**ALERT SERVICE BULLETIN**  
REVISION NOTICE  
**Bell Helicopter****TEXTRON**  
A Subsidiary of Textron Inc.

SUBJECT: **REVISION "A" TO ALERT SERVICE BULLETIN 206L-04-132:  
LOW LEVEL DETECTOR SWITCH UNIT P/N 206-063-613-003,  
REMOVAL FROM SERVICE OF**

**NO.** 206L-04-132

<b>DATE</b>	Oct 4, 2004
<b>REV</b>	A

Figure 1

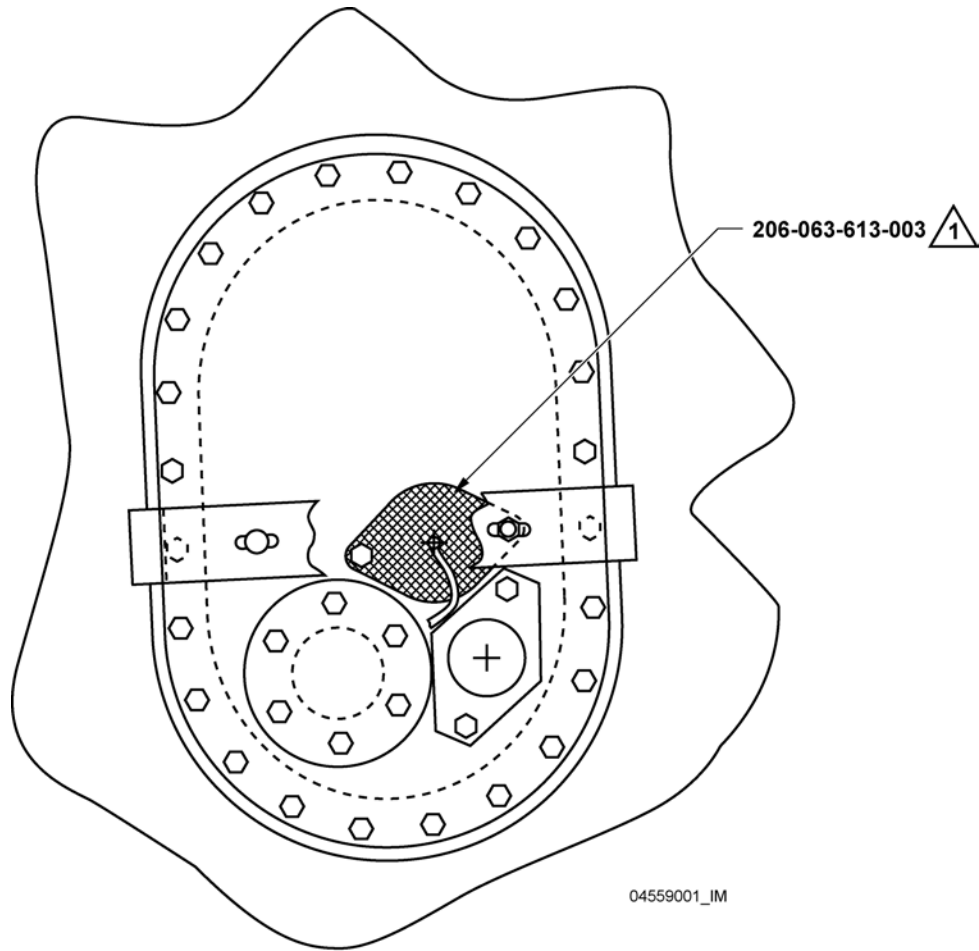
- Change compliance for PART I and II of this bulletin.
- Clarify the identification of the affected Fuel Low Level Detector switch.
- Add Figure 1 to show the Fuel Low Level Detector switch physical location and serial number location.

The serial number for the switch may be found on the outside face of the unit attachment flange. The switch is located on the aft fuel boost pump assembly. Refer to figure 1.

1. Upon receipt of this bulletin, proceed as follows to identify affected switches:
  - a. Check the Serial Number of the switch on the mounting flange. Refer to FIG 1.
    - i. If it is one of the affected Serial Numbers, proceed with PART II of this bulletin.
    - ii. If it is not one of the affected Serial Numbers, annotate the aircraft records to indicate compliance with this bulletin.
    - iii. If the Serial Number is missing or unreadable, proceed with step 2. of this bulletin.
